Subject: Assessment of Ark Properties LLC Water Supply Bank rental application

Date: April 14, 2010
To: Steve Lester
From: Craig Tesch^{CT} and Sean Vincent^{SV}
cc: Rick Raymondi
Subject: Technical Review of Groundwater Modeling in Support of Idaho Water Company Water Right Transfer #73811

Date: 18 February 2010
To: Craig Tesch
From: Allan Wylie *AW*
cc: Rick Raymondi, Sean Vincent
Subject: Review of Shekinah Model

Figure 1 – Location of PODs in relation to the Mountain Home Ground Water Management Area and the Cinder Cone Critical Ground Water Area.

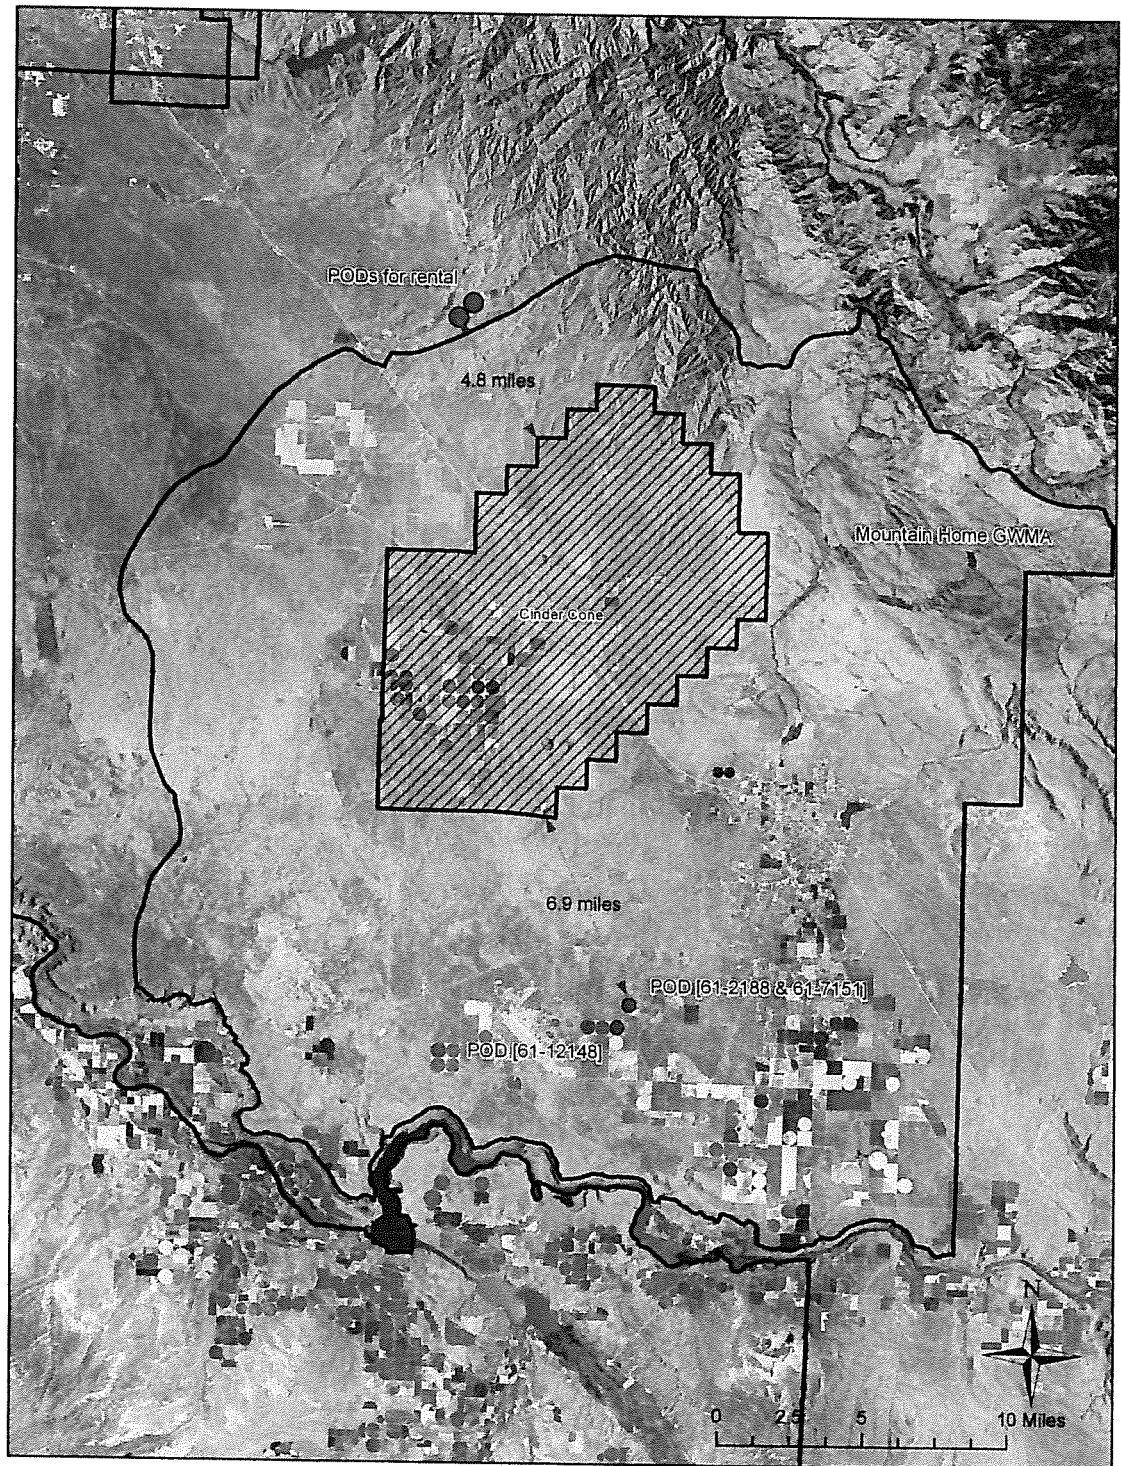
1. There is a possibility of injuring a water user whenever a groundwater point of diversion (POD) is relocated. However, in this case, the relocation is not permanent and it involves movement of two PODs from an area within the Mountain Home Ground Water Management Area (MHGWMA) to an area that is outside the management area (Figure 1).

3. Because the common groundwater resource is both heterogeneous and not well-characterized, the hydrologic impact of the temporary transfer cannot be predicted with confidence. Conceptually, movement of PODs from inside the MHGWMA to an area just outside the boundary is potentially beneficial to the aquifer system within the management area. On the other hand, the new PODs are actually closer to the Cinder Cone Critical Ground Water Area (~5 miles) than the old PODs (~7 miles). As concluded in the April 14, 2010 review of a modeling analysis that was performed in support of water right transfer #73811 (Attachment 1), movement of PODs closer to the boundary of critical area is a concern because it potentially exacerbates hydrologic conditions within the critical area.

Figure 3. Spring 2000 water level contours for the Mountain Home groundwater monitoring network (Harrington, 2001).

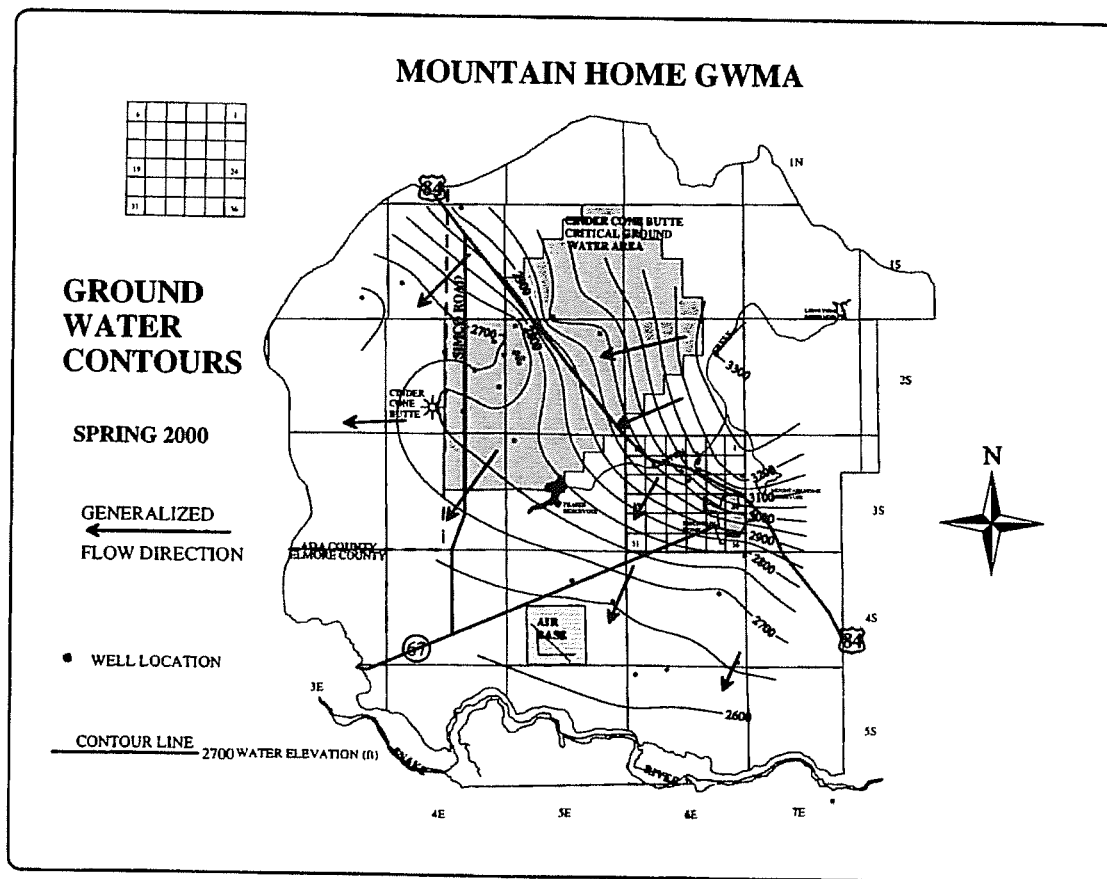
actual water levels and goodness of fit is calculated by comparing simulated heads to measured water levels. The statement in the modeling report that “no current published groundwater contours were available for the region” (Powell, 2009, p. 23) does not explain the rationale for deciding to not use recent water level data for model calibration. In fact, a groundwater contour map could have been created from the 2000 water level data (see Figure 3) or from the 2009 data.

Figure 4. Groundwater level change from spring 1983 to spring 2009 within the IDWR Mountain Home monitoring network.

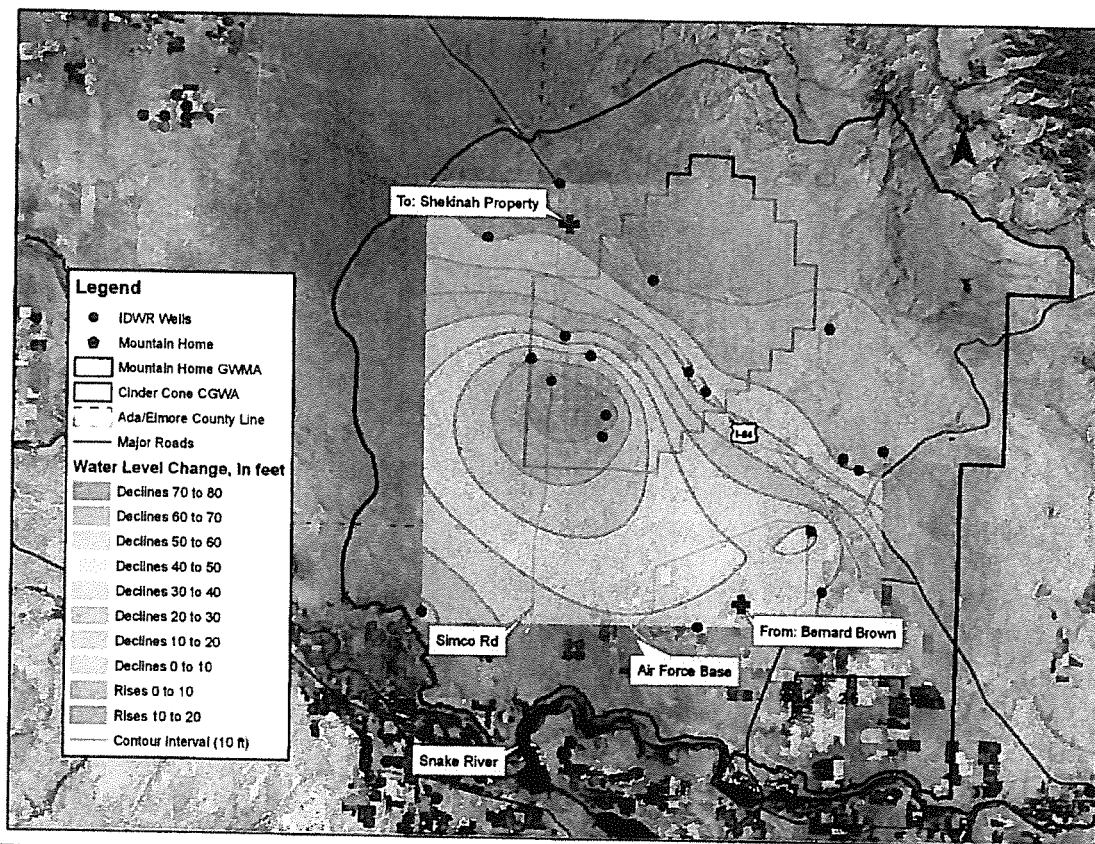
Five of the six wells in which water level increases were observed are located northeast of interstate I-84. The current PODs are located in an area with declines of 30 to 40 ft over the last 26 years, while the proposed PODs are in an area in which the water level

has risen from 0 to 10 ft. The cause of differing trends is currently unknown; there is significant uncertainty about aquifer behavior in this area due to a general lack of hydrogeologic data.

Northwest-trending faults mapped in the area (Bond, 1978) may serve as partial barriers to flow and contribute to the difference in trends between wells north/northeast of I-84 and those south/southwest of I-84. Additionally, irrigation development near Simco Road in the southwestern portion of the CGWA likely is affecting the distribution of water level declines. Studies performed as part of the IDWR Treasure Valley Comprehensive Aquifer Management Planning (CAMP) program will provide hydrologic information to facilitate a more rigorous evaluation of the factors affecting water levels in the GWMA and CGWA.

After reviewing historical water level declines (Figure 4) and drawdown contours developed by the Brockway Engineering model, IDWR has no reason to disagree with the following statements in the Powell (2009) report:

Large differences in groundwater level trends exist between the locations of the current and proposed POU (Figure 4). As Brockway Engineering states, “The groundwater elevations near the northwest portion of the Cinder Cone Butte Critical Groundwater Area have been experiencing a slight increase in elevation over the last few years, while the area near the southeastern portion of the critical groundwater area have seen steady declines” (Powell, 2009, p. 25). The extent to which stable or increasing trends in the vicinity of the proposed PODs could offset any pumping effects is unknown.
